Service Bulletin

01-071

The Evaporator Core May Crack in Models 579/567 Vehicles Built With a Cummins ISX-15 Engine.

11/22/2019

Line routing diagram

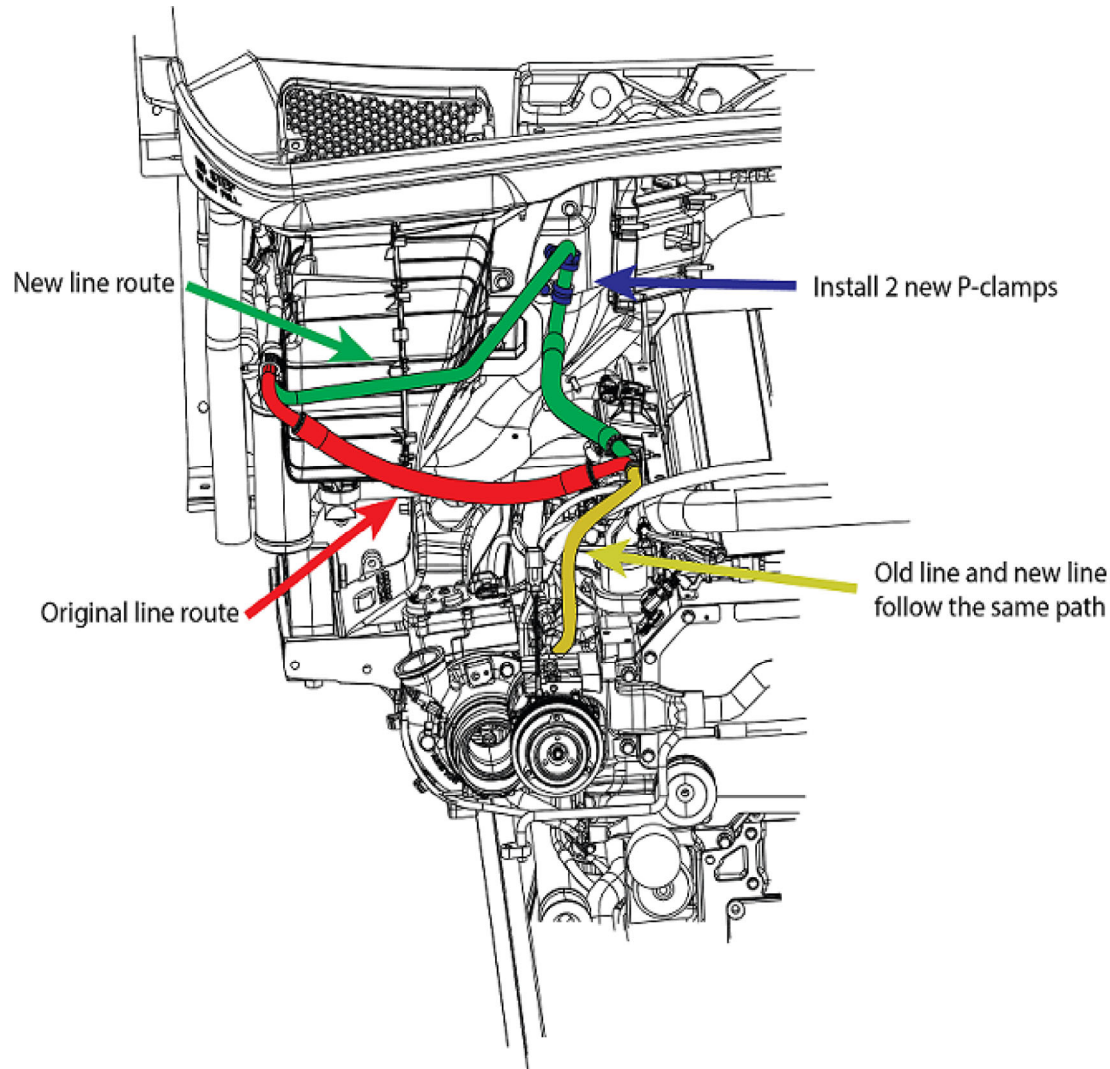
- The intermediate line located between the suction line and the evaporator core **MUST** be replaced if the old style (F50-1780) intermediate line is present.
- The updated suction line (F50-2188) is secured to the plenum with two p-clamps and the existing bolts. Refer to the routing diagram below for updated routing.
